AMERICANS WITH DISABILITY ACT (ADA) FACILITY ASSESSMENT REPORT

Americans with Disabilities Act (ADA) Facility Barrier Report

For Selected Park Sites

July 2024

Rockwood Central Park

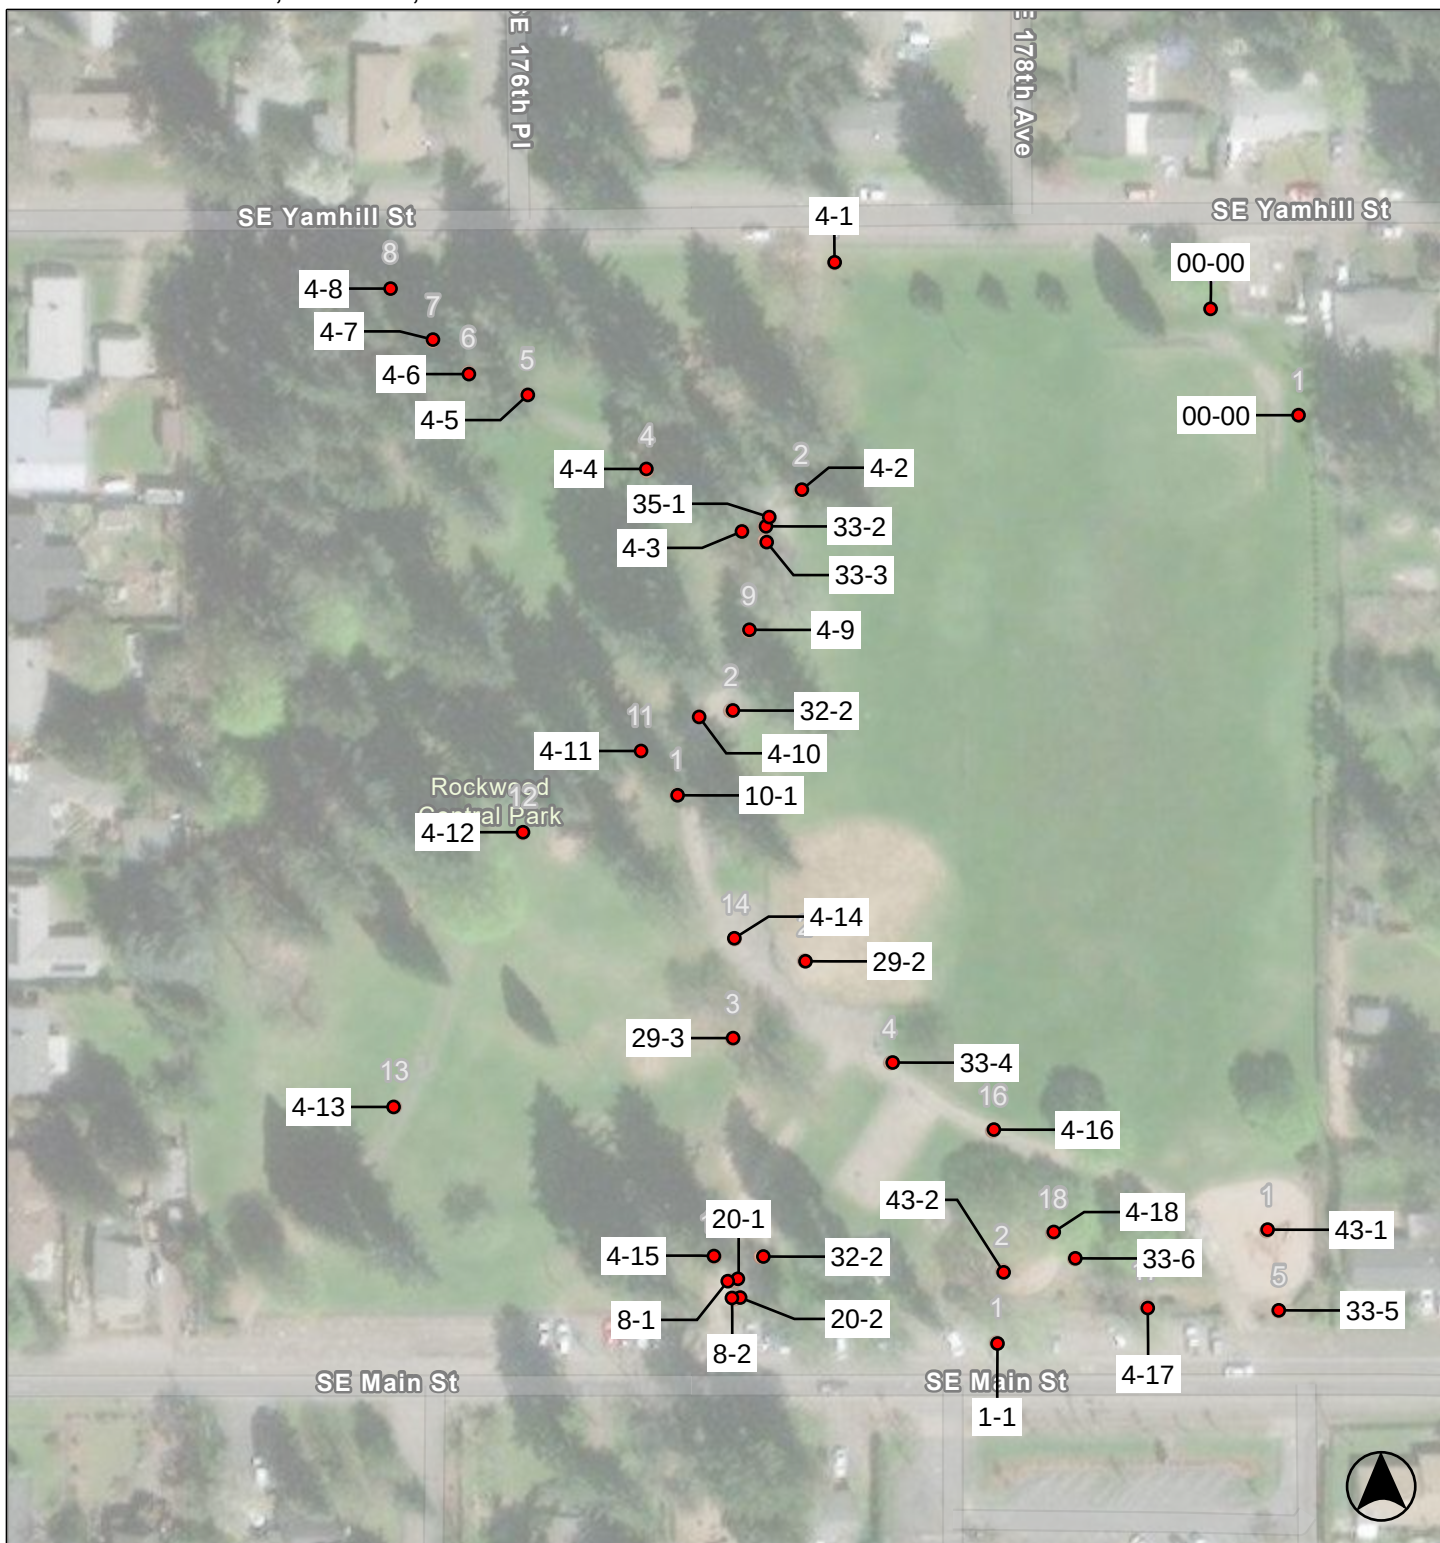
Park		
1 - 1	Parking Area	Category: 1
Provide or modify accessible spaces		\$4,050
Notes: Parking lot with 54 total parking spaces of which zero are accessible parking spaces. Two additional spaces are needed (0 min space(S); 26 to 50 parking spaces).		
ADA: 208.2		
Other: OSSC 1106.1		
Provide a firm, stable and slip resistant surface		\$0
Notes: Parking space and access aisle is not firm and stable.		
ADA: 302.1, 502.4		
Other: -		
Provide adequate striping		\$180
Notes: A marked access aisle is not provided.		
ADA: -		
Other: OSSC 1106.7		
4 - 1	Walk	Category: 1
Regrade surface		\$2,500
Notes: Running slope of concrete is up to 8.9% for 25 linear feet (5.0% max).		
ADA: 403.3		
Other: -		
Reduce or eliminate opening		\$300
Notes: Gap at concrete joint is greater than 1/2" (1/2" max).		
ADA: 302.3		
Other: -		
4 - 2	Walk	Category: 1
Grind or patch vertical change of grade		\$100
Notes: Surface level change is 1/2" at concrete joint (1/4" max; up to 1/2" with a 1:2 bevel).

Park		
4 - 4	Walk	Category: 1
Regrade surface		\$1,500
Notes: Running slope of concrete is up to 6.3% for 15 linear feet (5.0% max).		
ADA: 403.3		
Other: -		
Grind or patch vertical change of grade		\$100
Notes: Surface level change is greater than 1/4" at crack in concrete (1/4" max; up to 1/2" with a 1:2 bevel).		
ADA: 303.2, 303.3		
Other: -		
4 - 5	Walk	Category: 1
Regrade surface		\$100
Notes: Running slope of concrete is up to 10.5% for 5 linear feet (5.0% max).		
ADA: 403.3		
Other: -		
Grind or patch vertical change of grade		\$100
Notes: Surface level change is greater than 1/4" at crack in concrete (1/4" max; up to 1/2" with a 1:2 bevel).		
ADA: 303.2, 303.3		
Other: -		
4 - 6	Walk	Category: 1
Grind or patch vertical change of grade		\$100
Notes: Surface level change is 1/2" at crack in concrete (1/4" max; up to 1/2" with a 1:2 bevel).		
ADA: 303.2, 303.3		
Other: -		
4 - 7	Walk	Category: 1
Regrade surface		\$300

Notes: Running slope of concrete is up to 5.9% for 3 linear feet (5.0% max).		
ADA: 403.3		
Other: -		
Grind or patch vertical change of grade		\$100
Notes: Surface level change is 1/2" at crack in concrete (1/4" max; up to 1/2" with a 1:2 bevel). (x2)		
ADA: 303.2, 303.3		
Other: -

Park		
4 - 8	Walk	Category: 1
Grind or patch vertical change of grade		\$100
Notes: Surface level change is 1" at crack in concrete (1/4" max; up to 1/2" with a 1:2 bevel).		
ADA: 303.2, 303.3		
Other: -		
4 - 9	Walk	Category: 1
Grind or patch vertical change of grade		\$100
Notes: Surface level change is 1/2" at concrete joint (1/4" max; up to 1/2" with a 1:2 bevel).		
ADA: 303.2, 303.3		
Other: -		
Regrade surface		\$2,800
Notes: Cross slope of concrete is up to 5.1% for 28 linear feet (2.0% max).		
ADA: 403.3		
Other: -		
4 - 10	Walk	Category: 1
Regrade surface		\$400
Notes: Cross slope of concrete is up to 2.6% for 4 linear feet (2.0% max).		
ADA: 403.3		
Other: -		
4 - 11	Walk	Category: 1
Regrade surface		\$2,200
Notes: Cross slope of concrete is up to 3.6% for 22 linear feet (2.0% max).		
ADA: 403.3		
Other: -		
Reduce or eliminate opening		\$300
Notes: Gap at concrete joint is greater than 1/2" (1/2" max).

Park		
4 - 12	Walk	Category: 1
Regrade surface		\$4,600
Notes: Running slope of concrete is up to 8.6% (5.0% max) and cross slope is up to 3.6% (2.0% max) for 46 linear feet.		
ADA: 403.3		
Other: -		
Grind or patch vertical change of grade		\$100
Notes: Surface level change is greater than 1/2" at concrete joint (1/4" max; up to 1/2" with a 1:2 bevel).		
ADA: 303.2, 303.3		
Other: -		
4 - 13	Walk	Category: 1
Grind or patch vertical change of grade		\$100
Notes: Surface level change is 1" at crack in concrete (1/4" max; up to 1/2" with a 1:2 bevel).		
ADA: 303.2, 303.3		
Other: -		
4 - 14	Walk	Category: 1
Regrade surface		\$12,200
Notes: Cross slope of concrete is up to 4.1% for 122 linear feet (2.0% max).		
ADA: 403.3		
Other: -		
4 - 15	Walk	Category: 1
Regrade surface		\$5,100
Notes: Cross slope of concrete is up to 3.6% for 51 linear feet (2.0% max).		
ADA: 403.3		
Other: -		
Grind or patch vertical change of grade		\$100

Notes: Surface level change is greater than 1/4" at concrete joint (1/4" max; up to 1/2" with a 1:2 bevel).		
ADA: 303.2, 303.3		
Other: -		
4 - 16	Walk	Category: 1
Regrade surface		\$4,700
Notes: Cross slope of concrete is up to 2.6% for 47 linear feet (2.0% max).		
ADA: 403.3		
Other: -

Park		
4 - 17	Walk	Category: 1
Regrade surface		\$2,200
Notes: Cross slope of concrete is up to 3.6% for 22 linear feet (2.0% max).		
ADA: 403.3		
Other: -		
Grind or patch vertical change of grade		\$100
Notes: Surface level change is 1/2" at concrete joint (1/4" max; up to 1/2" with a 1:2 bevel).		
ADA: 303.2, 303.3		
Other: -		
4 - 18	Walk	Category: 1
Grind or patch vertical change of grade		\$100
Notes: Surface level change is 1" at concrete joint (1/4" max; up to 1/2" with a 1:2 bevel).		
ADA: 303.2, 303.3		
Other: -		
8 - 1	Door/Gate	Category: 1
Adjust door closer		\$160
Notes: Door opening force is 7 lbs (5 lbs max).		
ADA: 404.2.9		
Other: OSSC 1102.1.2.5		
Regrade surface		\$625
Notes: Slope of the exterior landing is 3.6% (2.0% max).		
ADA: 404.2.4.4		
Other: -		
8 - 2	Door/Gate	Category: 1
Regrade surface		\$625
Notes: Slope of the exterior landing is 3.7% (2.0% max).		
ADA: 404.2.4.4		
Other: -		
Replace door hardware		\$550

Park		
10 - 1	Drinking Fountain	Category: 3
Confirm water flow compliance		\$0
Notes: Water service to the drinking fountain was disconnected at the time of the assessment. Flow height and angle could not be confirmed.		
ADA: 602.3, 602.6		
Other: -		
20 - 1	Single User Restroom	Category: 2
Install restroom sign		\$250
Notes: Replace sign. Sign contains hole and cracks that could cause injury. Letters are not tactile, braille is not provided beneath text.		
ADA: 216.8		
Other: -		
Replace or reposition fixtures		\$1,590
Notes: The water closet centerline is 18-1/2" from the wall (16" min to 18" max).		
ADA: 604.2		
Other: -		
Replace or reposition dispenser		\$160
Notes: The centerline of the toilet paper in front of the water closet is 12" (7" min and 9" max).		
ADA: 604.7		
Other: -		
Replace or adjust water controls		\$640
Notes: Water flow was not operational on the day of assessment		
ADA: 309.4, 606.4

Park		
20 - 2	Single User Restroom	Category: 2
Install restroom sign		\$250
Notes: Replace sign. Broken edges could cause injury. Letters are not tactile, braille is not provided beneath text.		
ADA: 216.8		
Other: -		
Replace or reposition fixtures		\$1,590
Notes: The water closet centerline is 18-1/2" from the wall (16" min to 18" max).		
ADA: 604.2		
Other: -		
Replace or reposition dispenser		\$160
Notes: The centerline of the toilet paper in front of the water closet is 12" (7" min and 9" max).		
ADA: 604.7		
Other: -		
Replace or adjust water controls		\$640
Notes: Water flow was not operational on the day of assessment		
ADA: 309.4, 606.4		
Other: -		
29 - 1	Game and Sports Area	Category: 2
Provide an accessible route		\$16,560
Notes: An accessible route to the baseball backstop is not provided. Route from the nearest path to the backstop is 207 linear feet over grass. Route from the public right-of-way is 85 linear feet over grass.

ADA: 206.2.2		
Other: -		
Enlarge accessible route		\$190
Notes: Clear width of the route to the player seating is 30 inches due to overgrown grass. (36" min wide).		
ADA: 404.2.3		
Other: -		
Provide wheelchair seating		\$1,800
Notes: Debris in the wheelchair space for players.		
ADA: 802.1		
Other: -

Park		
29 - 2	Game and Sports Area	Category: 2
Provide companion seating		\$1,780
Notes: Cross slopes in team wheelchair spaces are between 4.2 - 6.2% (2.0% max). (x2)		
ADA: 221.3, 802.3.1, 802.3.2		
Other: -		
29 - 3	Game and Sports Area	Category: 2
Provide an accessible route		\$8,000
Notes: Multiple disc golf launch pads are not connected via an accessible route. Estimated total length of missing routes is 100 ft.		
ADA: 206.2.2		
Other: -		
32 - 1	Picnic Area	Category: 2
Provide an accessible table		\$3,250
Notes: Knee clearance measured 8" horizontally from the front face of the table top is 24" (27" min).		
ADA: -		
Other: ABA 306.3		
32 - 2	Picnic Area	Category: 2
Provide an accessible table		\$3,250
Notes: Knee clearance measured 8" horizontally from the front face of the table top is 24-1/2" (27" min).		
ADA: -		
Other: ABA 306.3		
Reduce or eliminate opening		\$300
Notes: The picnic area has 1-1/2" openings at gap between the path and picnic area (1/2" max).

Park		
32 - 3	Picnic Area	Category: 2
Increase or provide clear floor area		\$200
Notes: The clear space around the picnic table narrows down to 24" (36" min wide).		
ADA: -		
Other: ABA 1011.2.1		
Provide an accessible picnic unit		\$4,060
Notes: The picnic facility provides four picnic units and one are designed for accessibility (20% min but not less than two picnic units are required to be accessible). At least two accessible picnic units are required.		
ADA: -		
Other: ABA F245.2.2		
33 - 1	Outdoor Constructed Features	Category: 3
Increase or provide clear floor area		\$200
Notes: A clear floor space is not provided at the trash container opening (36" by 60" min parallel approach or 36" by 48" min forward approach).		
ADA: -		
Other: ABA 1011.2		
33 - 2	Outdoor Constructed Features	Category: 3
Increase or provide clear floor area		\$200
Notes: Clear floor space at the trash container opening has a 2" change of level and gaps greater than a 1/2" (36" by 60" min parallel approach or 36" by 48" min forward approach).

ADA: -		
Other: ABA 1011.2		
33 - 3	Outdoor Constructed Features	Category: 3
Increase or provide clear floor area		\$200
Notes: The clear ground space adjacent to the bench is 30" deep (36" by 48" min).		
ADA: -		
Other: ABA 1011.2.1, ABA 1011.2.3		
33 - 4	Outdoor Constructed Features	Category: 3
Increase or provide clear floor area		\$200
Notes: The clear floor space for the trash container has a cross slope of 3.8% (2.0% max).		
ADA: -		
Other: ABA 1011.2

Park		
33 - 5	Outdoor Constructed Features	Category: 3
Provide an accessible route		\$1,200
Notes: An accessible route to the fixed bench is not provided. Route is 15 linear feet over woodchips from curb to bench.		
ADA: -		
Other: ABA F206.2.2		
33 - 6	Outdoor Constructed Features	Category: 3
Increase or provide clear floor area		\$200
Notes: A clear ground space is not provided adjacent to the bench (36" by 48" min). Companion space overlaps with the path of travel.		
ADA: -		
Other: ABA 1011.2.1, ABA 1011.2.3		
35 - 1	Other	Category: 3
Reposition controls		\$285
Notes: Operating mechanism of dog bag station is 65" above the ground (15" min to 48" max).		
ADA: 308.2, 308.2.1		
Other: -		
Increase or provide maneuvering or clear floor area		\$200
Notes: Clear floor space of the dog bag station contains an elevation change of 1/2" (1/4" max).		
ADA: 305.2, 305.3, 305.5		
Other: -		
43 - 1	Play Equipment Area	Category: 2

Improve or evaluate play area surface		\$0
Notes: Ground surface in play area is in need of maintenance and further evaluation of fall attenuation surface is recommended.		
ADA: 1008.2.6.1, 1008.2.6.2		
Other: -		
Provide play components		\$19,050
Notes: The play area has 9 elevated play components of 3 different types, with 0 ground components (for 8 to 10 elevated play components, 3 min ground components of 3 different types are required).		
ADA: 1008.2.1, 240.2.1.2		
Other: -
